July 3, 2013

Customer Service Notice

Units Affected: All 31 - 55 ft. Telescopic Jibs built between July 1, 2010 and May 1, 2011
(see attached list)

Jib Mounting Ear Inspection and Modification

Figure 1 — Jib Components

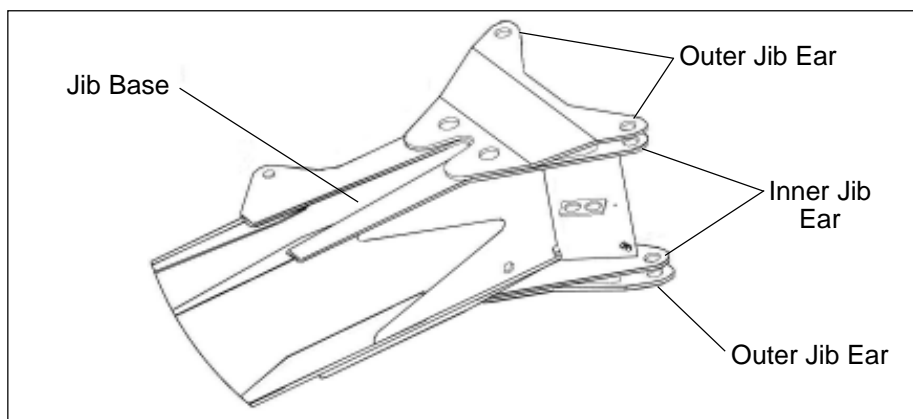
Altec has discovered that some jib ears, the part used to attach the jib to the crane boom (refer to Figure 1), were made from a material which will not perform properly under some jib loading conditions. While no jib failures have occurred, Altec requires an inspection of the jib attachment. Failure of the jib ear can result in the jib to become unattached from the crane boom. **Death or serious injury will occur from uncontrolled movement of the jib.**

Altec requires the customer to inspect all eight of the jib ears (four outer and four inner jib ears) for any damage. Customers must order the Inspection and Repair Kit, part number 970451260, to perform the inspection. The kit will include directions for the inspection procedure, a gauge to perform the inspection and parts to repair the jib ears, if required. Call 1-877-GO-ALTEC (1-877-462-5832) to order the inspection kit.

1. Receive this CSN and order Inspection and Repair Kit, part number 970451260
2. Receive Inspection and Repair Kit
 - Inspect jib using the gauge
 - Photograph each of the eight jib ears with the gauge in use
 - Email photographs to Altec Engineering
 - Altec Engineering responds to results of inspection (usually within the same day)
3. Perform repair determined by Altec response
 - No damage or deformation is found after the photographs are submitted to Altec:
Install the doubler kit on all jib ears before or at the next service interval.
[The jib can continue to be used provided that visual preoperational inspections listed in the Operator's Manual are performed on the jib ears.]
 - **If there is any deformation determined by Altec's analysis, a replacement base jib boom must be installed before the jib is used in service again.**
